## **DEVELOPMENT REVIEW COMMITTEE (DRC) COMMENT REPORT**

**Project Name:** 1324 Bay View Drive LLC / 1324 Bayview Drive  
Multifamily

**Case Number:** R15056

**Request:** Site Plan Level III Review: Waterway Use;  
Multifamily Units

1 EAST SIDE ELEVATION

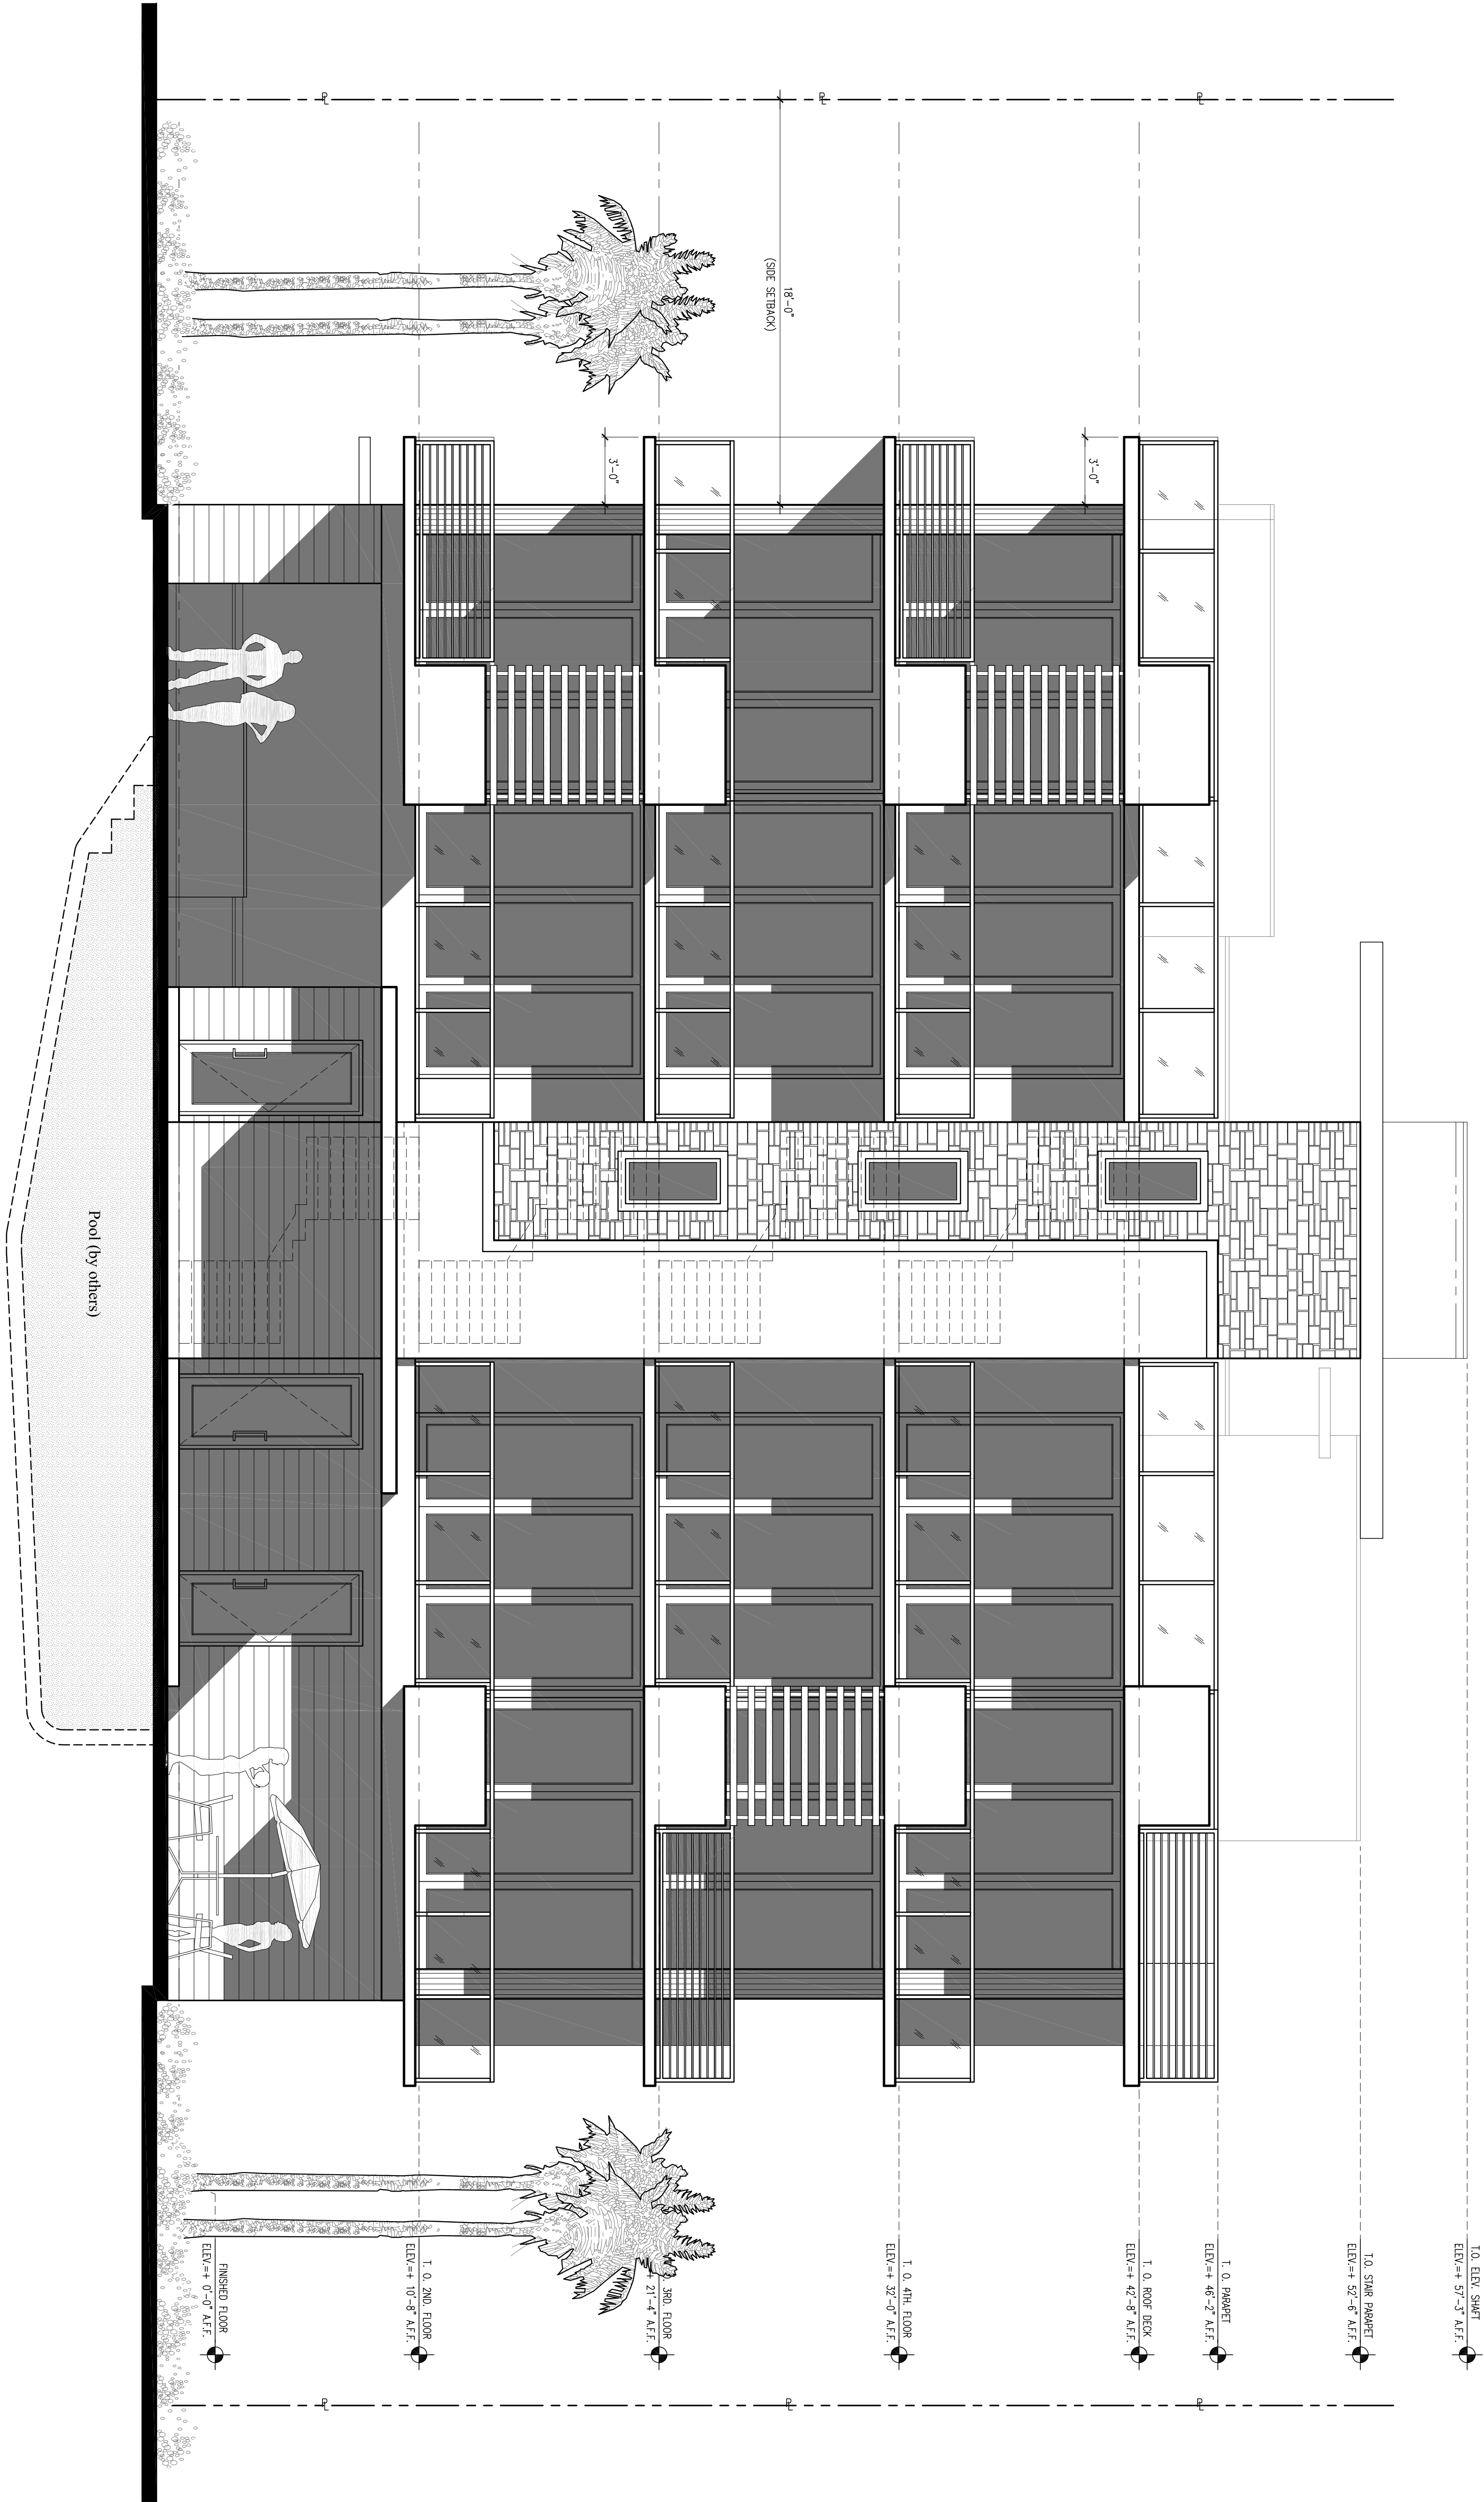
- c. Provide a comparative table on the site plan to indicate required and proposed setbacks for building, balconies and pool;
  - d. It appears that the highest habitable space is at the level of the overhang that covers the roof deck. Adjust the required setbacks based on the half of the height of the appropriate highest habitable space;

- e. Reduce the height of the staircase to 55 ft. in height;
  - f. Indicate all building footprints on adjacent properties, indicating their uses and heights, and dimension approximate setbacks;
